FUSELAGE - RADOME LATCH IMPROVEMENT

525 (M2)

SB525-53-21  
Page 1 of 5

Figure 1. Radome Latch Installation (Sheet 1)

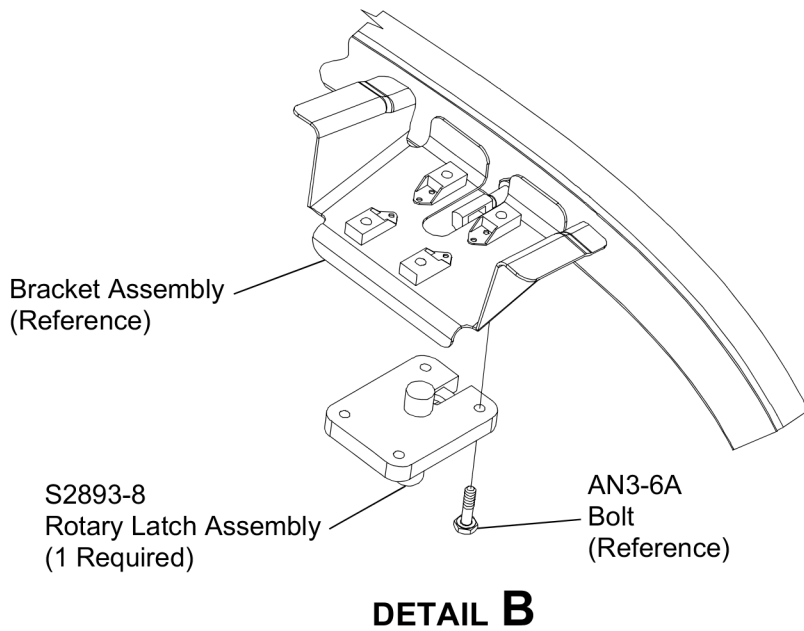
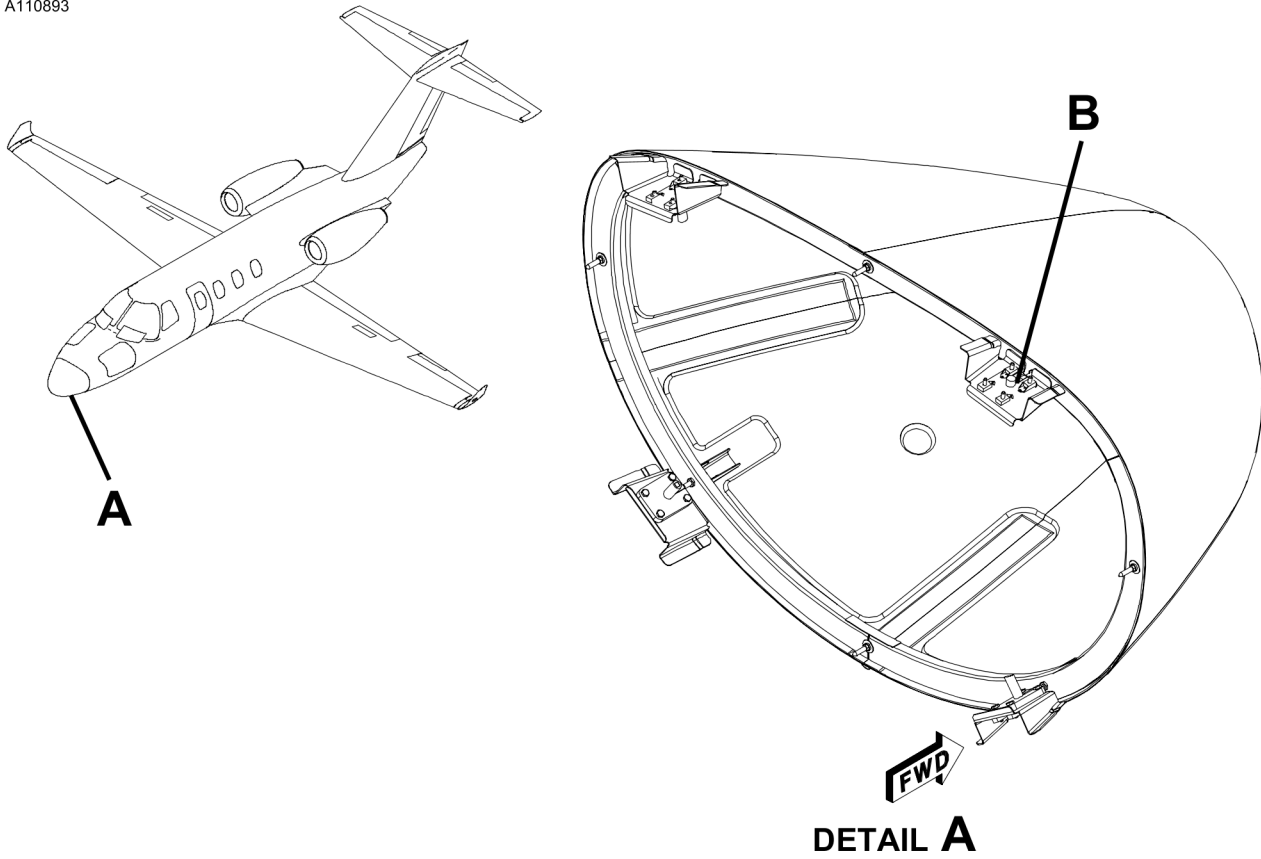
The current latch may be difficult to access with Garmin avionics boxes installed.

This service bulletin provides parts and instructions to replace the current latch with a shorter latch.

5. Remove and discard the S2893-15 Rotary Latch Assembly.
6. (Refer to Figure 1). Install the new S2893-8 Rotary Latch Assembly using the retained AN3-6A Bolts.

**NOTE:** Install S2893-8 with the latch opening facing forward.
7. Install the Nose Radome. (Refer to the 525 (0685 and 0800 & On) Maintenance Manual, Chapter 53, Nose Radome - Maintenance Practices).
